# APPEAL OF DECISION

New File #12-C-24-OB

## Middle Housing Staff Review

**TO:** R. Bentley Marlow, Contractor  
**FROM:** Planning Staff  
**DATE:** November 20, 2024  
**SUBJECT:** Middle Housing Review – 10-J-24-MH  
**ADDRESS:** 1216 Callaway St (Parcel ID 094FQ016)

FRONT ELEVATION

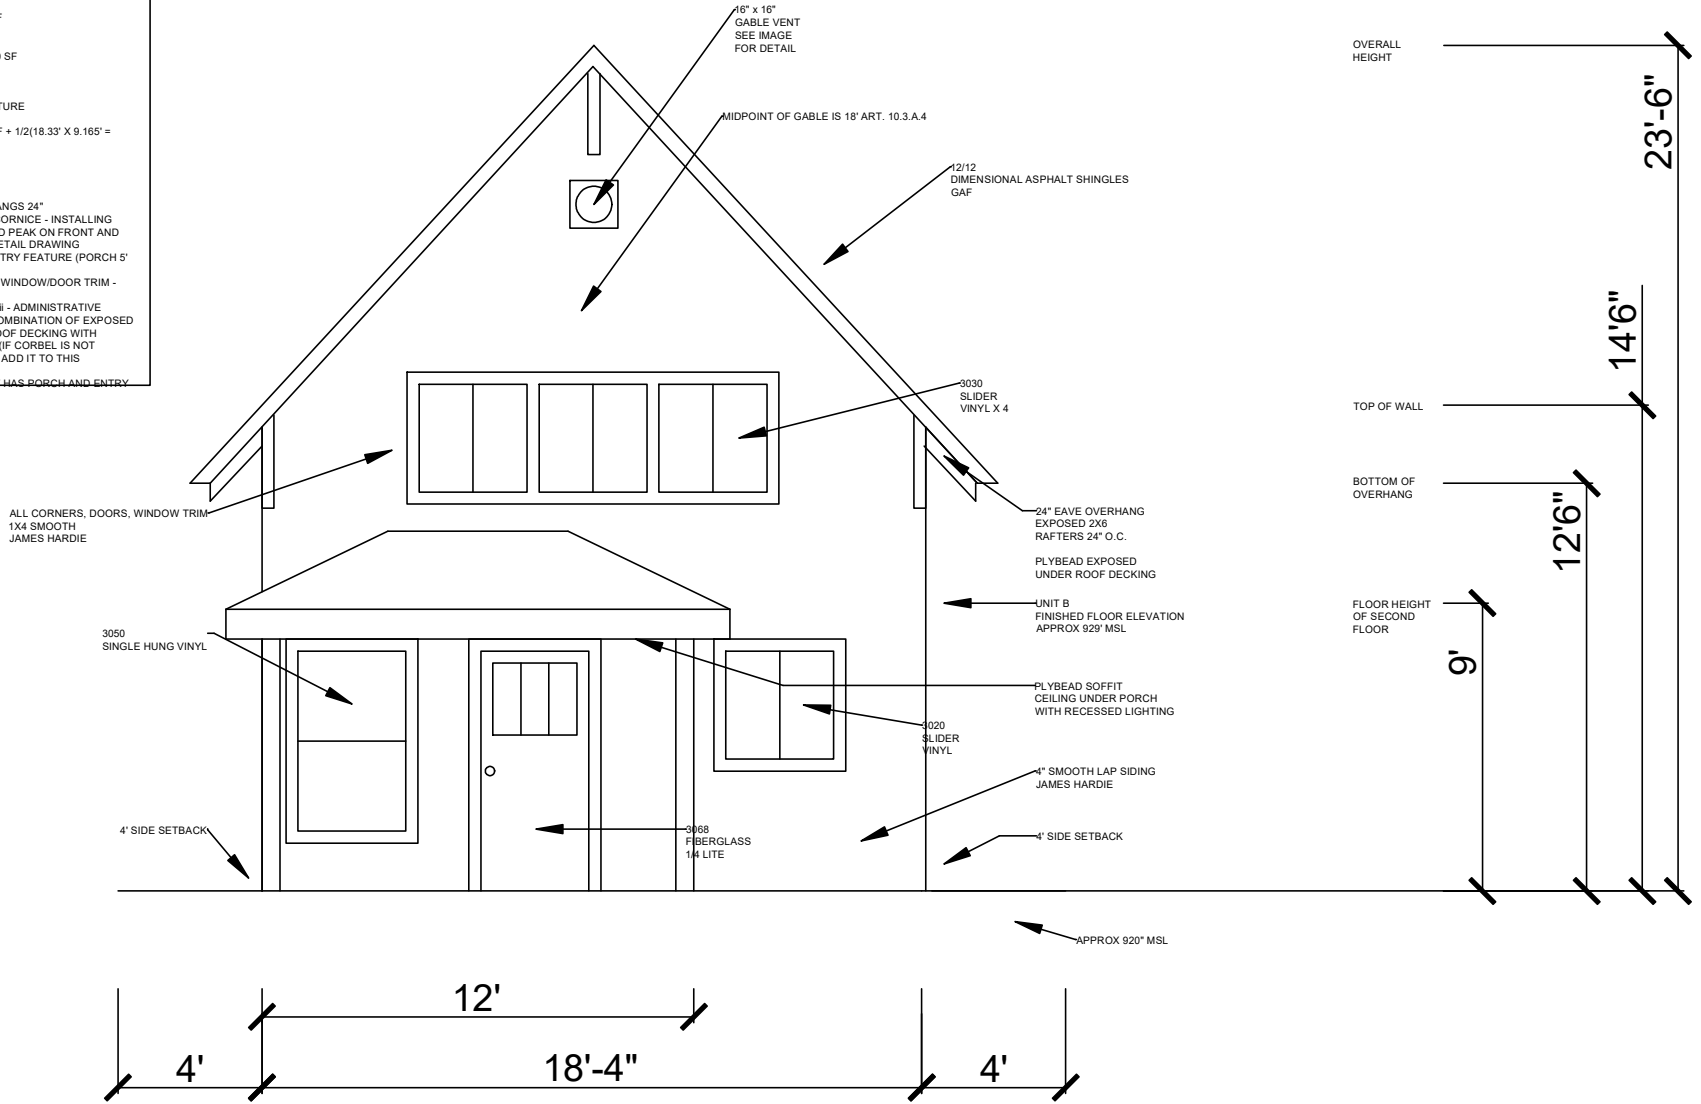
- The duplexes are oriented with the front elevation facing the rear of the existing house, with ground level entrances oriented towards the street but obscured by the existing house.

- The roofline is steep, with a 12/12 pitch. The drawings dated 11/18/24 have been revised to accurately depict the roofline.
- To satisfy Article 4.6.E.4.c, the project includes: one stoop, 24" eave overhangs and articulated window and door trim, including window sills (projecting sills shown on separate profile but location not indicated on elevation drawings) and requests an

SITE PLAN

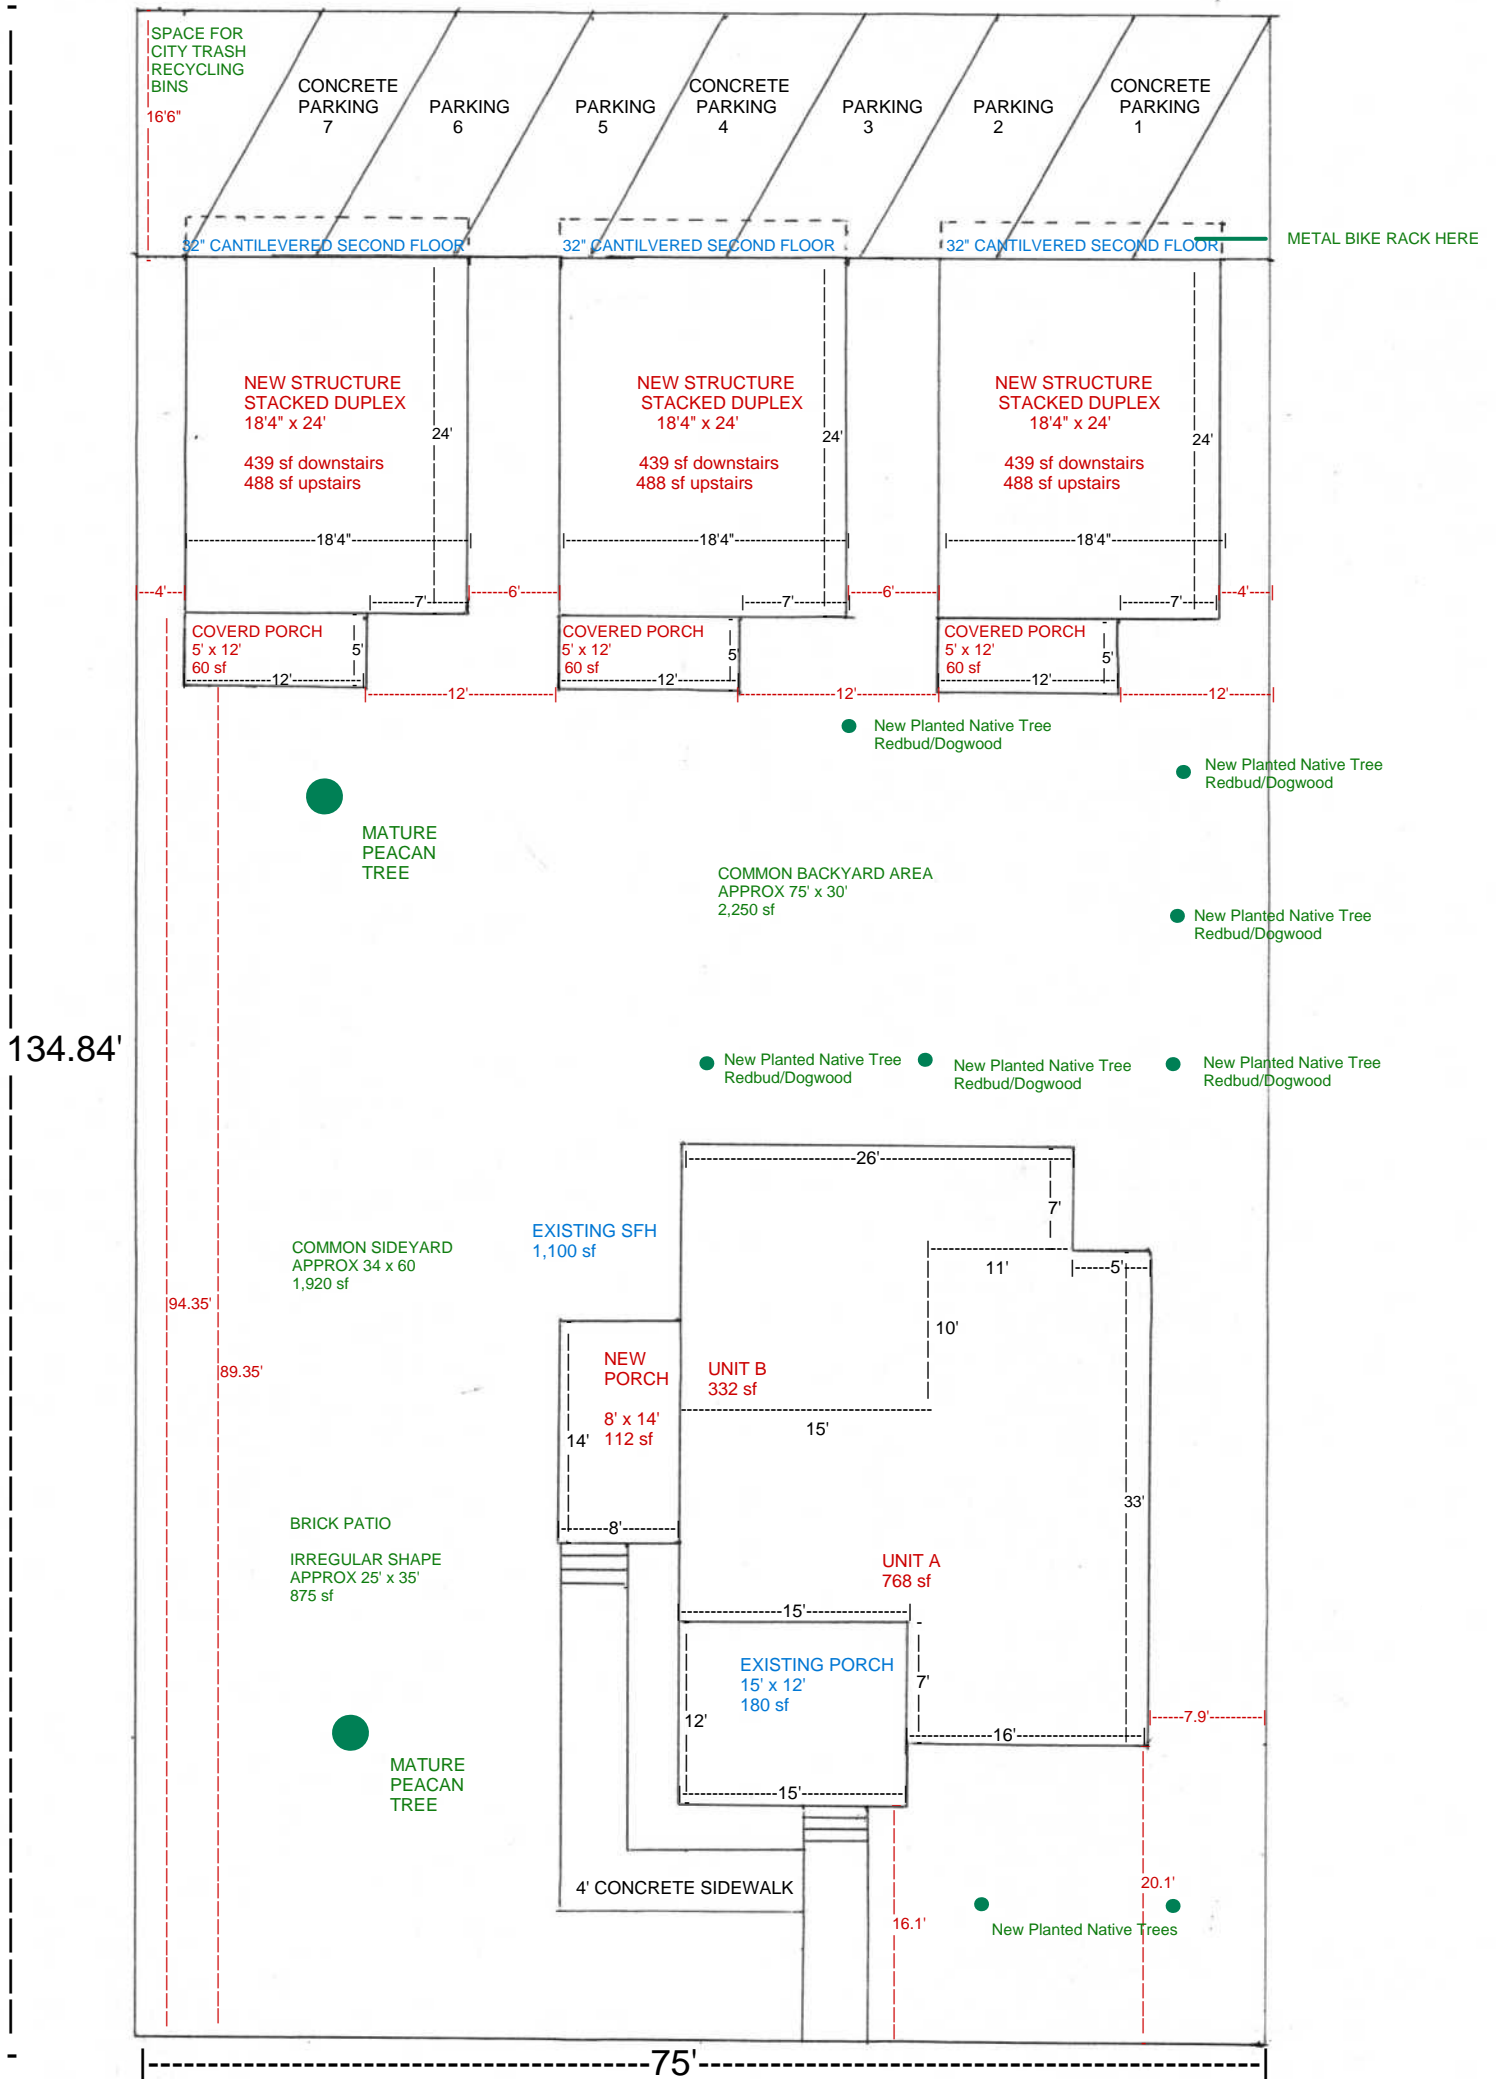
- The proposed front setback (shown as 94.35’) does not meet the zoning standard in Article 4.6.C.3.a: *“front setbacks for middle housing types shall be the average of the blockface, plus or minus five feet, in no case less than 10’.*

- The proposed duplexes do not meet the front setback requirement of Article 4.6.C.3, which states “front setbacks shall be the average of the blockface, plus or minus five feet, in no case less than 10 feet.”

- The proposed rightmost and leftmost buildings do not meet the 5' minimum interior side setbacks and requests two administrative variations of 20% on each side setback, reducing both side setbacks to 4'. The building meets the 15' minimum rear setback requirement.

- The application includes two administrative variations on interior side setbacks, reducing each by 20% to 4 feet.
  - Per City Engineering, Utility and Drainage Easements are dedicated on the plat and would conflict with the proposed structure. Those easements would need to be closed where structures would overlap.

Art. 2.4.O.2.b defines 'Front Setback' as "a front setback is the MINIMIUM distance per the zoning district that a principle building must be located from the front lot line." The site plan submitted complies with Art. 4.6.C.3.a "Front SETBACKS for Middle Housing" as the proposed new structure is setback approx. 95' feet from the front lot line, which complies with the requirement of "in no case less than 10 feet." Moreover, the original primary structure, (Front Setback 13'6") whose conversion to a Middle Housing Duplex has been approved, satisfies the Front SETBACK for this parcel.
